CREWSAVER SERVICING AND MAINTENANCE BULLETIN No. 43

Issued to: GAO, CGG
DATE ISSUED: 3rd January 2014
SUBJECT: Crewfit Twin 2010 with Cowtail
ISSUED BY: Carol Champney
EXP DATE: Not Applicable

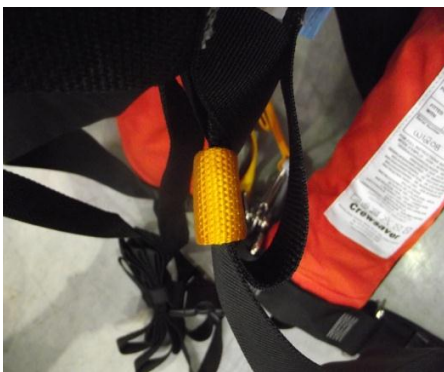
Please be advised that the threading of the cowtail on the 2010 Crewfit twin 1174-23 and 1174-24 has not been passed through the belt.

INCORRECT
 The images are showing the cowtail only attached to the cowtail retainer

CORRECT
 The images show the cowtail attached to the belt and the cowtail retainer

To rework. Unthread the belt pass through the cowtail re thread the belt.
